Reply to Comments on Stability Risk Assessment

Withyhedge Landfill Permit Variation

Restoration Sections

Drawing Number 2365/17

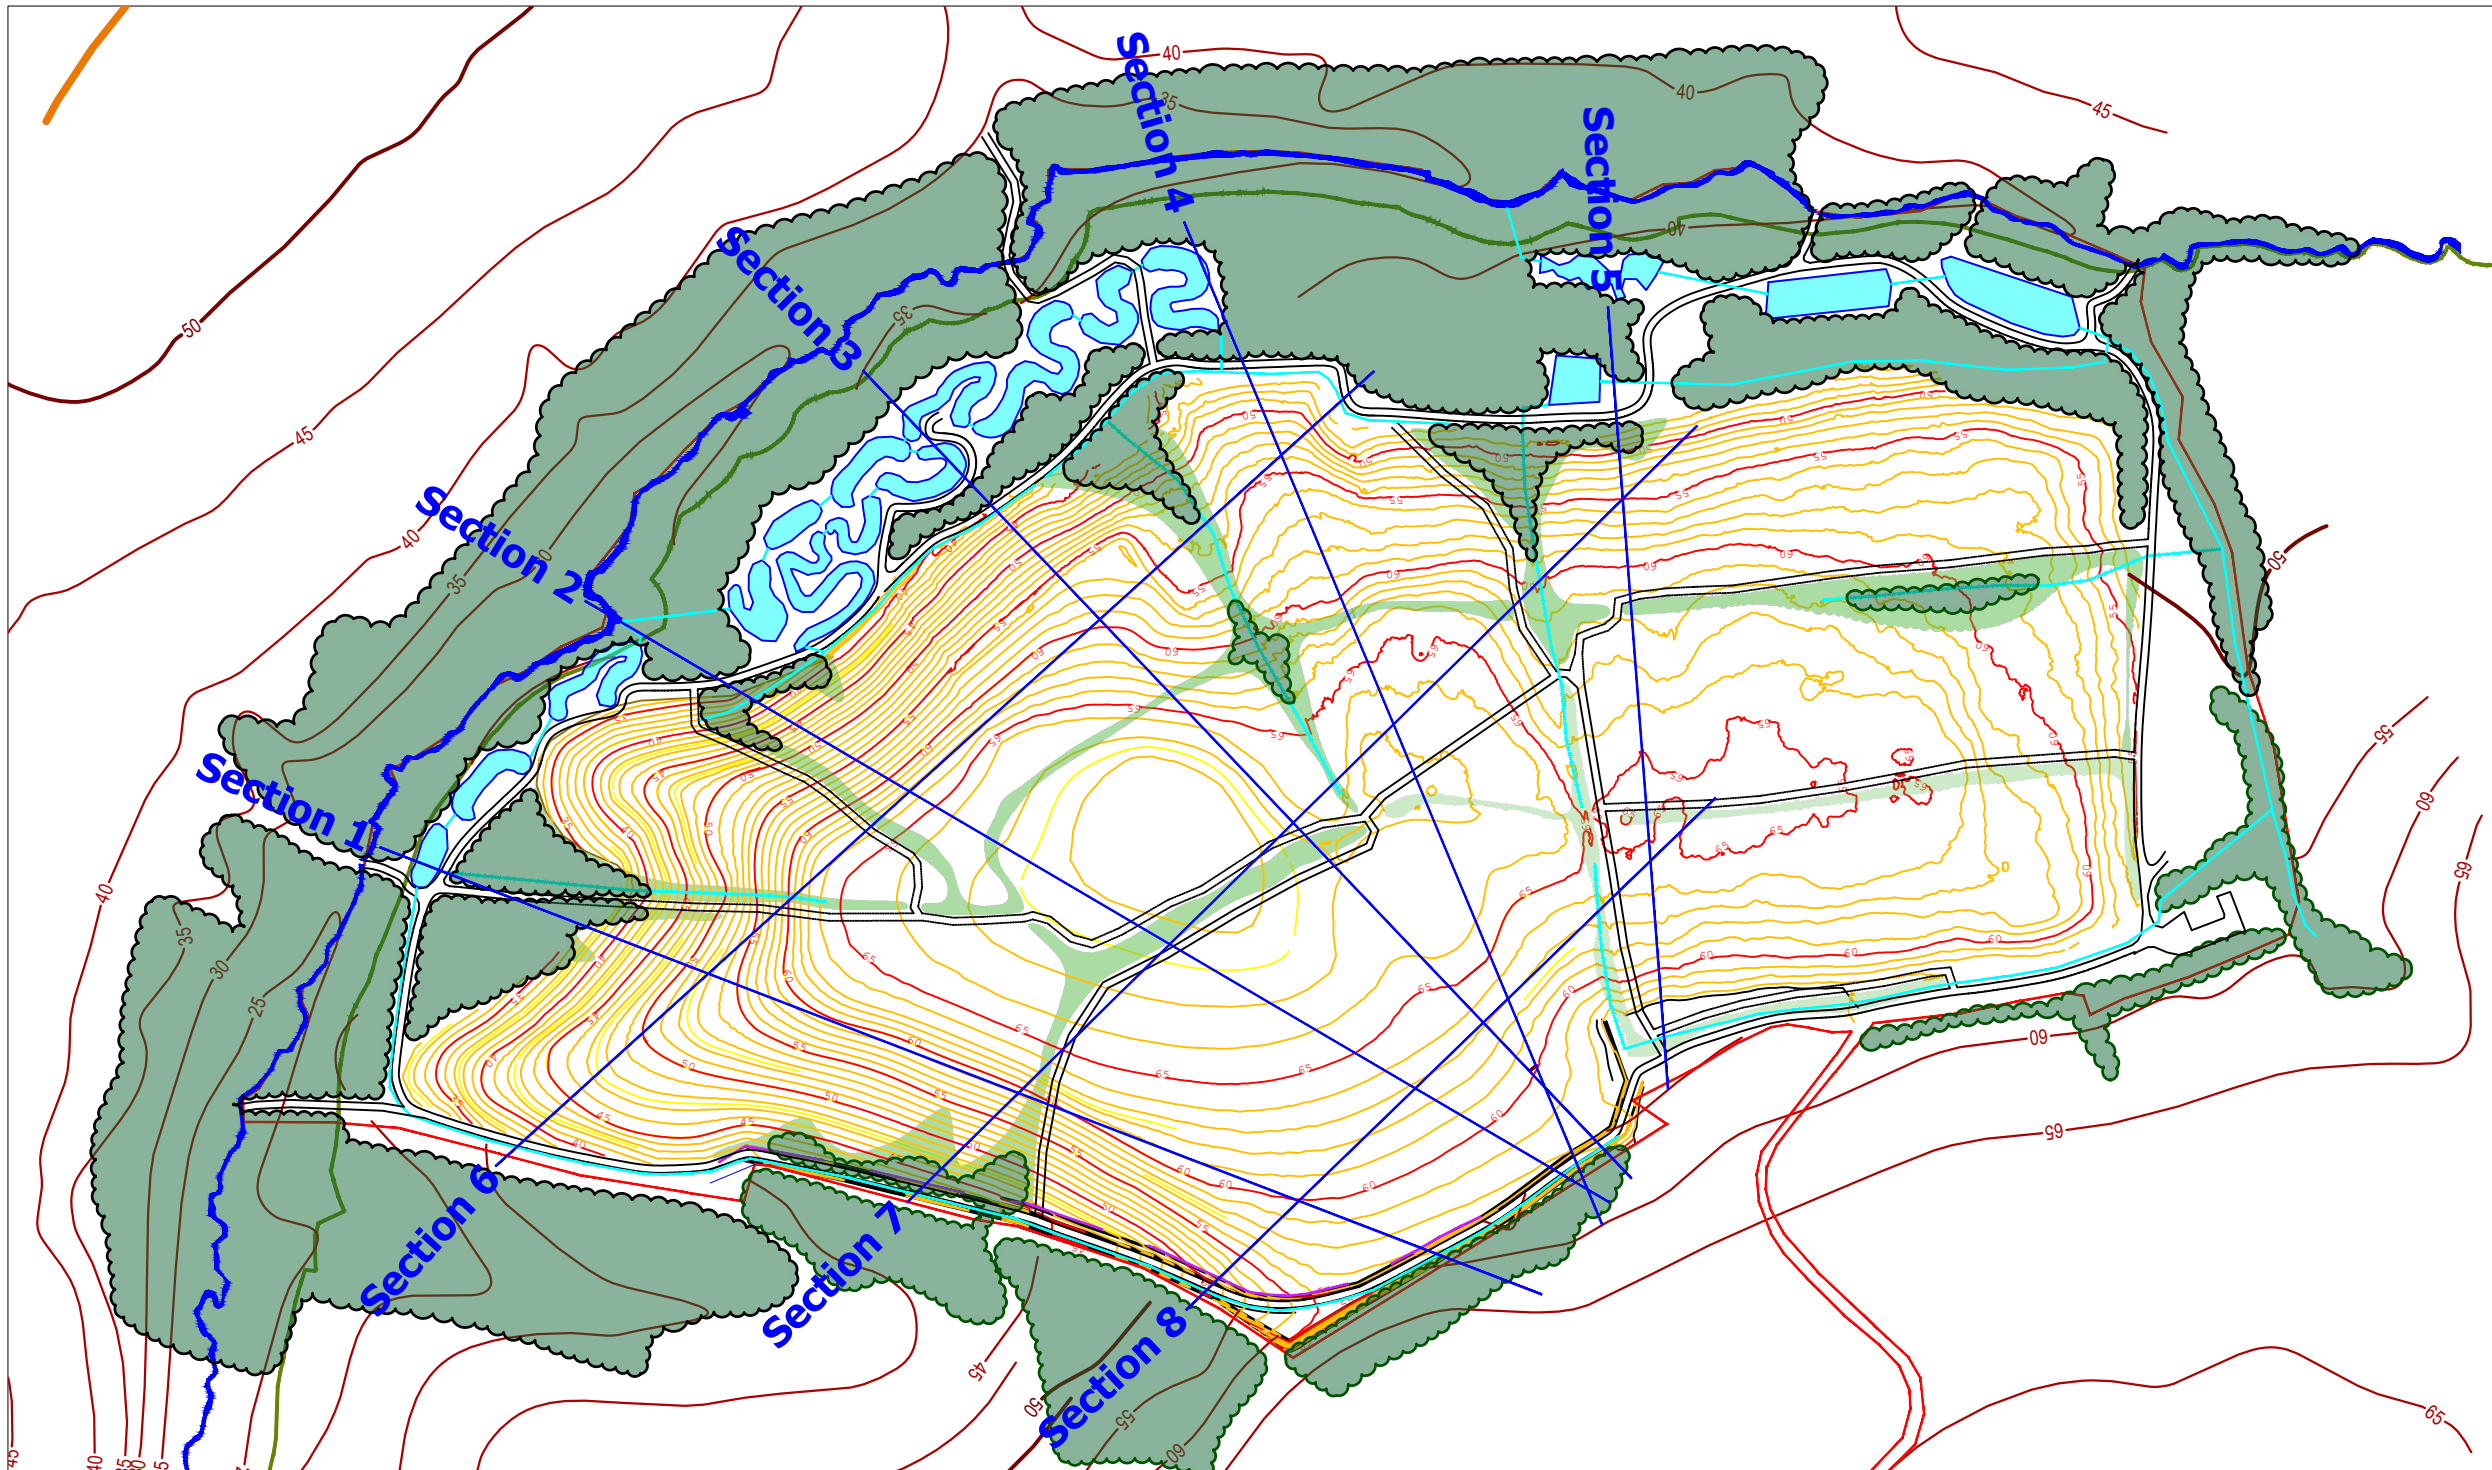
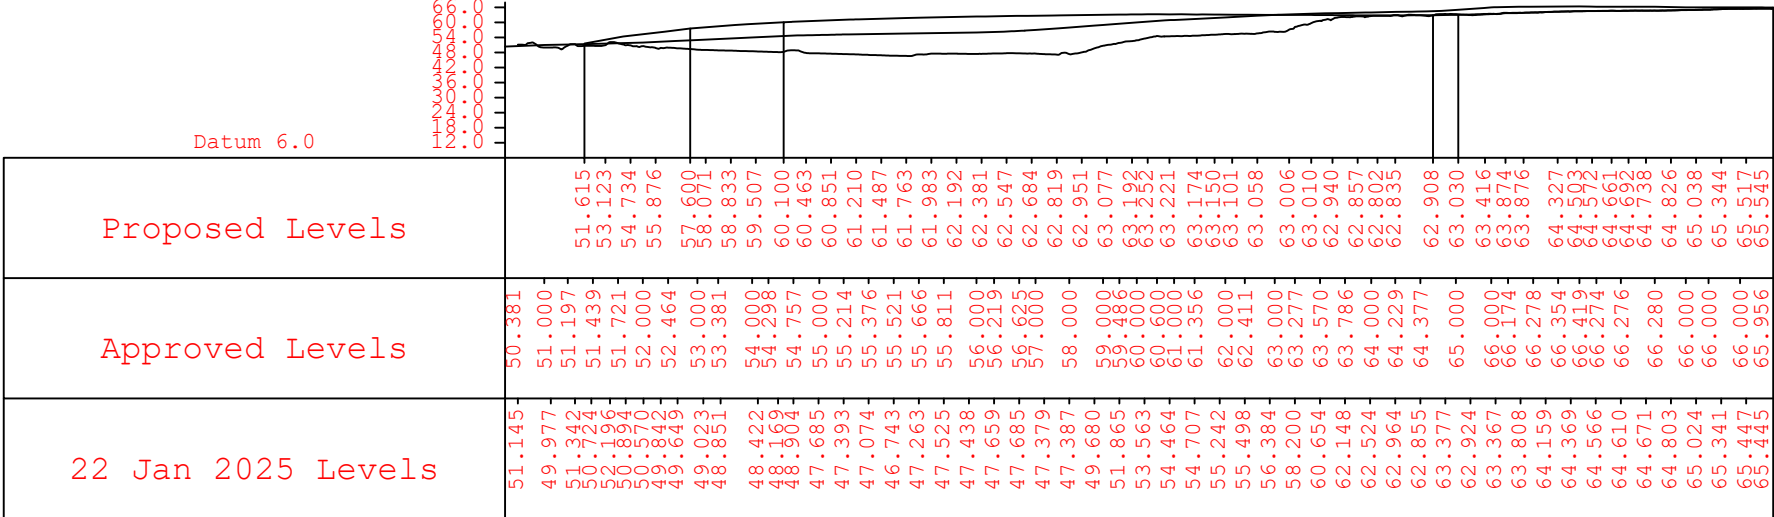
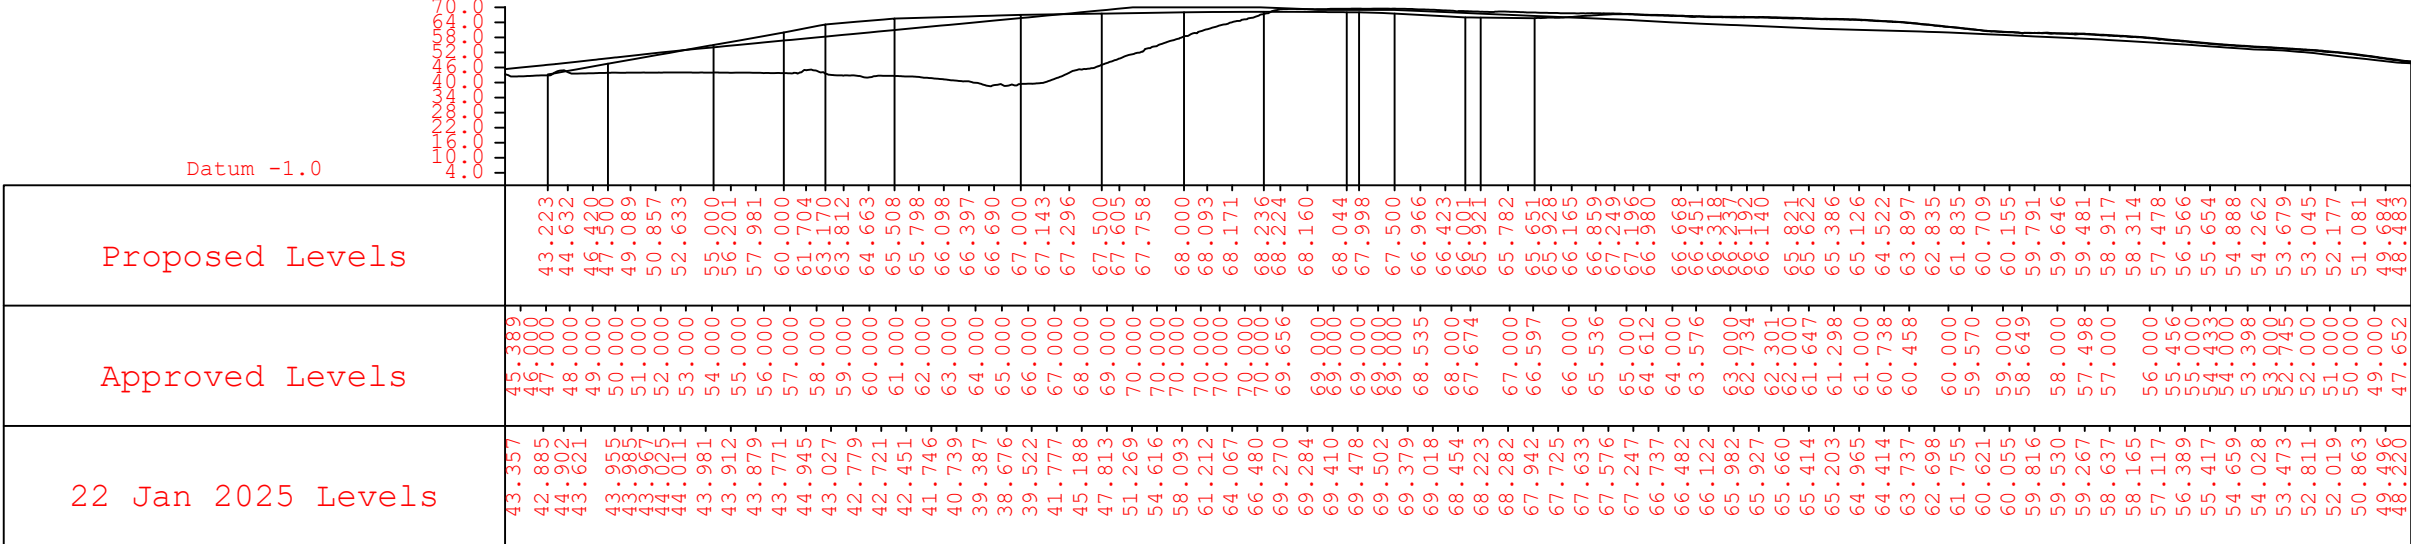
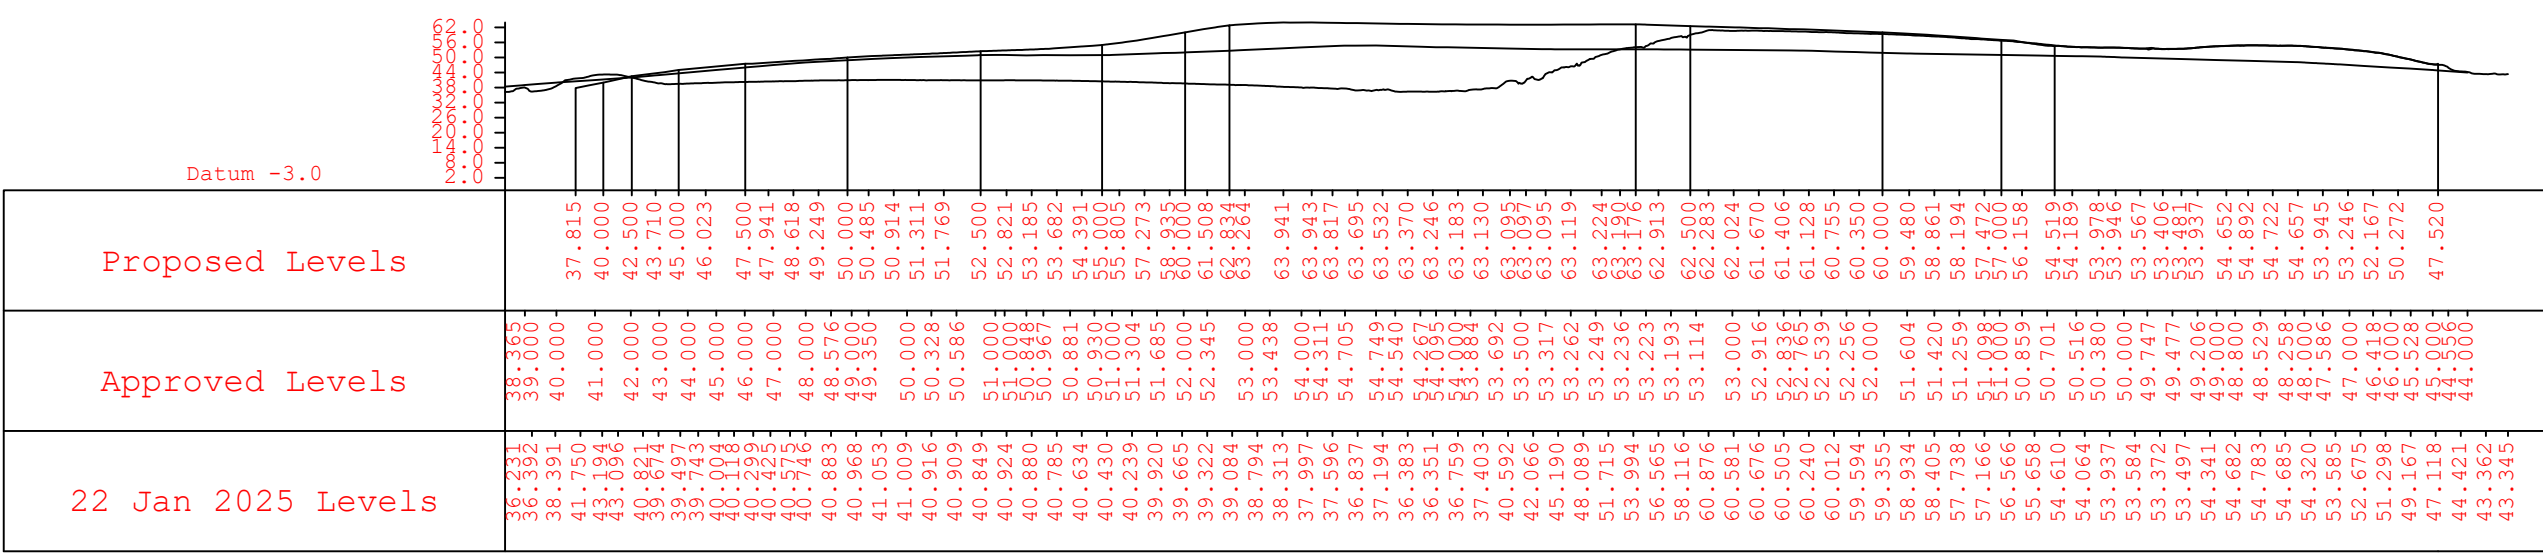
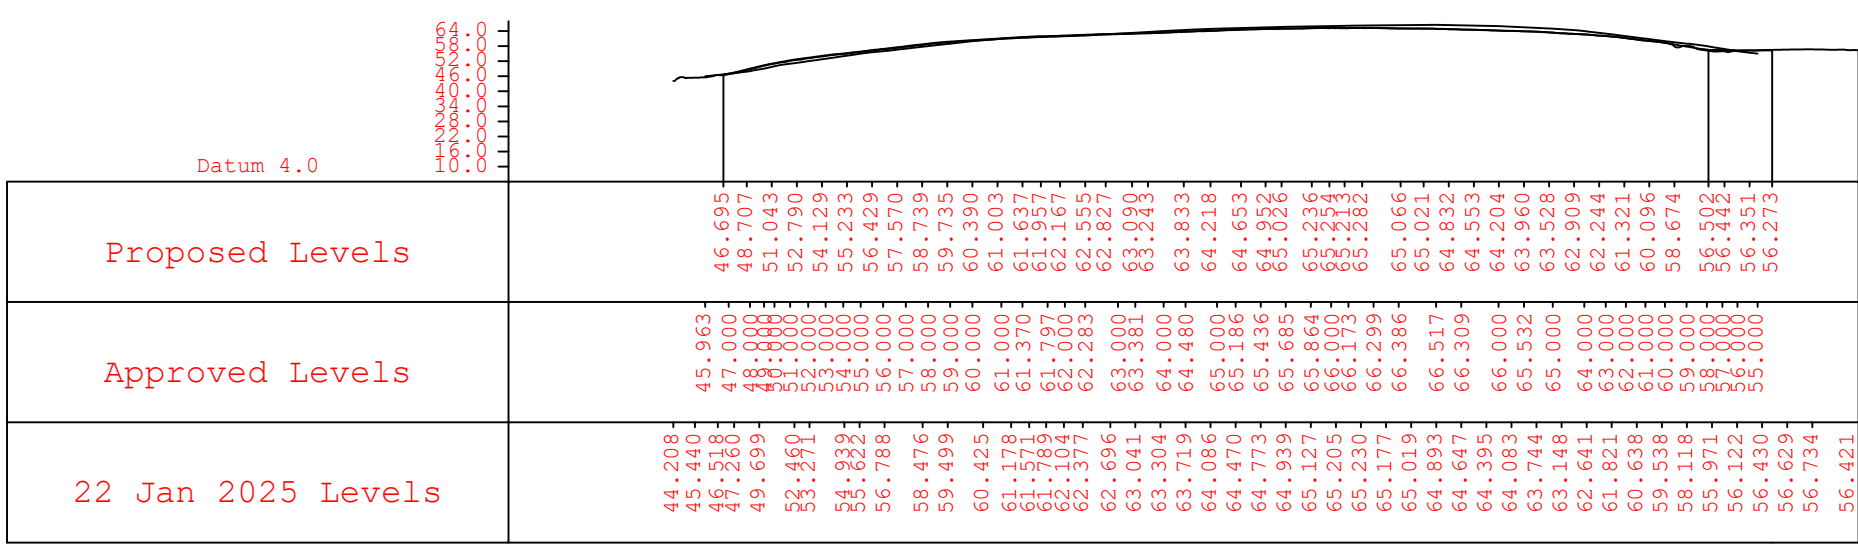
Only one cross section has been provided to illustrate the revised profiling. Please can you provide more cross sections from across the site, comparing the approved and proposed waste thickness and slope angles.

A series of cross sections have been produced as Drawing 2365/17 which is submitted along with this response. NRW is reminded that it has access to the full 3d modelling and topographic survey system shared with it by RML. In the event that any of the review team would like instruction on the use of the system Geotechnology will be happy to assist.
